Corrigendum-II

Refer IISER Mohali E-tender Ref. no. IISERM (874)17/18 Pur for **Supply of Gas Distribution System for EHEP lab** at IISER Mohali, Sector-81, Knowledge City, PO-Manauli, SAS Nagar Mohali, Punjab. Due date for the online submission is extended as per below schedule.

Clarifications to GAS Distribution System For EHEP Lab in AB2

Annexure - 1: IISERM (874) 17/18Pur

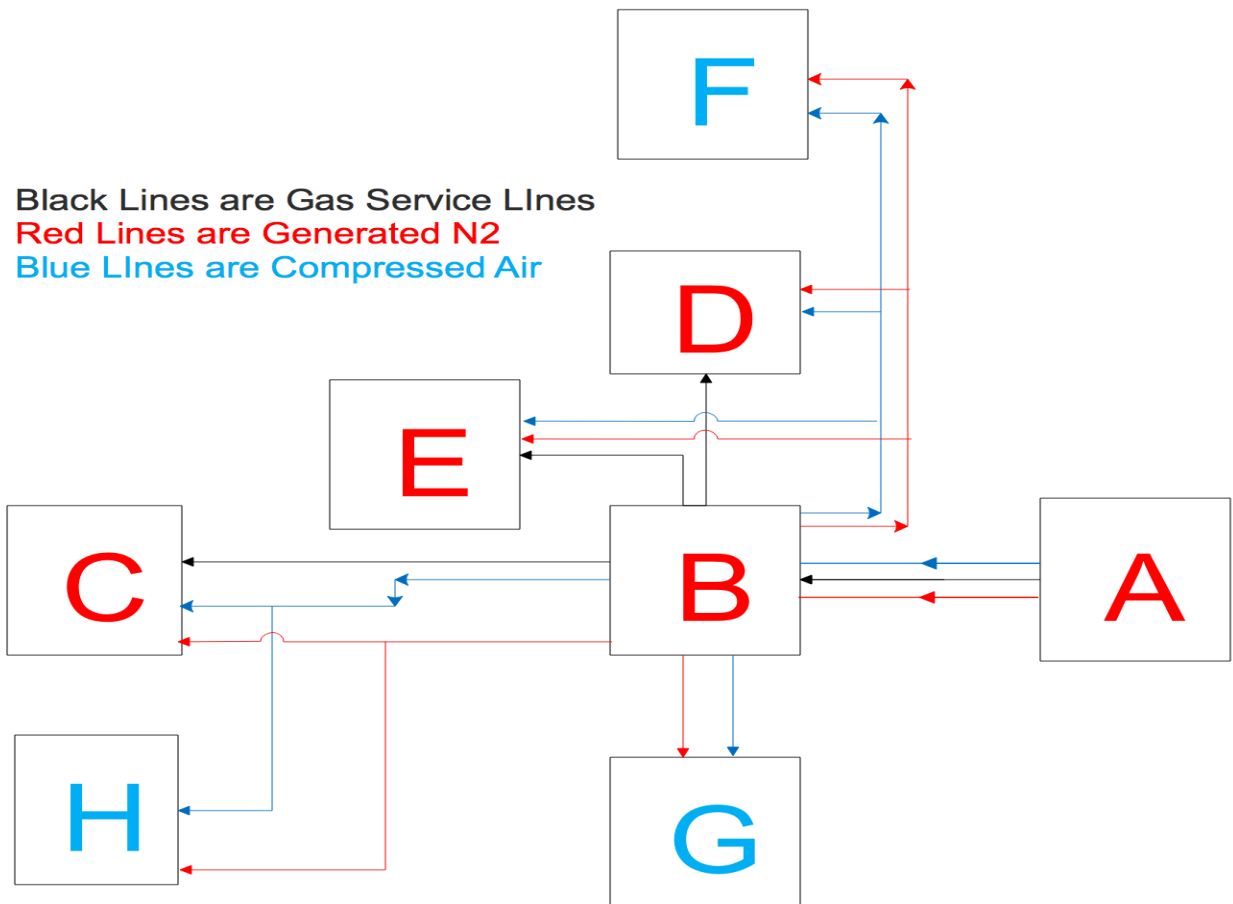
Sln	Detail Explanation and clarifications
1	<p>Layout and Schematics lab and gas bank:</p> <ol style="list-style-type: none"> 1. Top figures: shows the schematics and position representation of actual layout of buildings and utility areas. Although the dimensions are given in the schematics, vendors must take final measurement before installations. 2. Bottom Figure: Topological layout of different areas as shown in top figure to illustrate the connections and to lay the gas-service lines 3. The temperature at every utility points and areas including gas bank will be maintain at 22-24C throughout the year. 4. Bidder/Vender must organize cylinders as per requirements in the gas bank area. 5. Vendor must submit a proper layout/design and work plan during the bidding (3D-Flow diagram is preferable, but not mandatory)
2	<p>Point of Use:</p> <ol style="list-style-type: none"> 1. A: Gas Enclosure, ~60' away from the <i>Point-B</i> 2. B: Location of Control and Distribution Panel 3. C: Utility Area - 1 4. D: Cleanroom Utility Area 5. E: Utility Area - 2 6. F, G, H: Drop lines for Generated Nitrogen (GN) and Compressed Air (CA).

3	<p>Points-A:</p> <ol style="list-style-type: none"> 1. All gas cylinders will be kept in this area (Gas Bank) and pipelines must be routed through <i>Point-A</i> to connect <i>Point-B</i>. 2. Between <i>Point-A</i> to Utility Area <i>Point-B</i>, a rack with over-head shading will be provided. It is the responsibility of vendor to provide appropriate protective insulations to prevent gas lines from outside ambient disturbances like temperature, humidity and pressure. 3. Vendor must group gases in terms of oxidizing gas, toxic gases and flammable gas lines and must put a divided between these gas lines.
4	<p>Point-B:</p> <ol style="list-style-type: none"> 1. This is the point where Gas distribution panel and control system must be mounted on a SS wall mounting structure either anchored to ground or to available wall. 2. Distance between <i>Point-A</i> to <i>Point-B</i> is around 60' 3. All gas line must have pressure gauges installed at this point (including in blank lines, CA and GN).

5	<p>Point-E:</p> <ol style="list-style-type: none"> 1. This point is ~3' from <i>point-B</i>, a SS panel should be put anchored to the ground, which will be used as another point of use (utility area - 2) 2. All gas outlets G01-to-G18, GN, CA, and E-E5 should be made available at this point, where equipment will be connected. 3. Flammable, toxic and corrosive gas outlets should be kept inside respective VMBs and a diaphragm valve should be connected at the end, all other gases lines should be terminated using ball-valve endpoints
6	<p>Point-C:</p> <ol style="list-style-type: none"> 1. First Point of use (point of use – 1), which is ~22' from point-B and it is a non-cleanroom area. 2. Gases to be used: (Check Annexure-2 for coding convention): Ar, CO2, CF4,

<p>C4H10, Xe, N2, (G03, G, G13, G09, G11, G12, G14), E3, E4, GN, and CA</p> <ol style="list-style-type: none"> 3. All these gas lines should be terminated with valves (flammable gases with diaphragm type valve, and rests gases with ball valves) 4. Flammable gas outlet should be kept inside respective VMBs 5. Vendor should ensure to install a dedicated SS structure to host VMBs and panels, as <i>Point-C</i> doesn't have any solid wall.
6	<p>Point-D:</p> <ol style="list-style-type: none"> 1. Point of use (Inside cleanroom), which is ~8' from point-B. 2. Gases to be used: (Check Annexure-2 for coding convention): Ar, N2, CH4, CO2, C2H2F4, SF6, C4H10 (G03, G08, G13, G09, G11, G12, G14) E1, E2, GN, and CA 3. All these gas lines should be terminated with valves (flammable gases with diaphragm type valve, and rests gases with ball valves) 4. Flammable gas outlet should be kept inside respective VMBs 5. Vendor should ensure to install a dedicated SS structure to host VMBs and panels as <i>Point-D</i> doesn't have and solid wall.

7	<p>Point-F, G, H:</p> <ol style="list-style-type: none"> 1. CA and GN lines should be routed until these points and provide a set of drop points at each point with a valve at each end point. 2. There are six drop points for both CA and GN lines. More clarification of A.2 of NIT: CA line must have a common central regulator and six regulators for six drop points; Similarly, GN line must have a common central regulator and six regulators for six drop points. 3. Point-G is ~30' from Point-B 4. Point-H is ~17' from Point-C 5. Point-H is ~30' from Point-B
8	<p>General:</p> <ol style="list-style-type: none"> 1. All gases are listed in Annexure-2, Vendors must be calculated appropriate numbers of valves, joints, connector, manifolds etc. as per gases, using above requirements to evaluate BOQs and to prepare P & IDs. 2. All end-points should be temporality shielded by a dummy pluck 3. Exhausts of VMBs should be connected back to respective gas cabinets, and exhaust should be done through respective common outlets after leak detection.
